Los Alamos Canyon and Pueblo Canyon Intermediate and Regional Aquifer Groundwater Work Plan
12/23/03

Patrick Longmire and Kelly Bitner

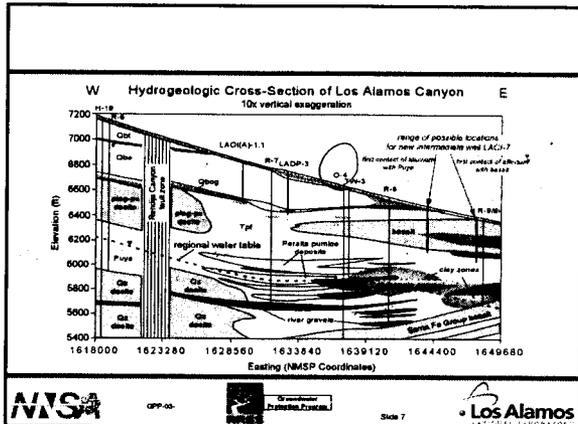
R-6 is not yet installed
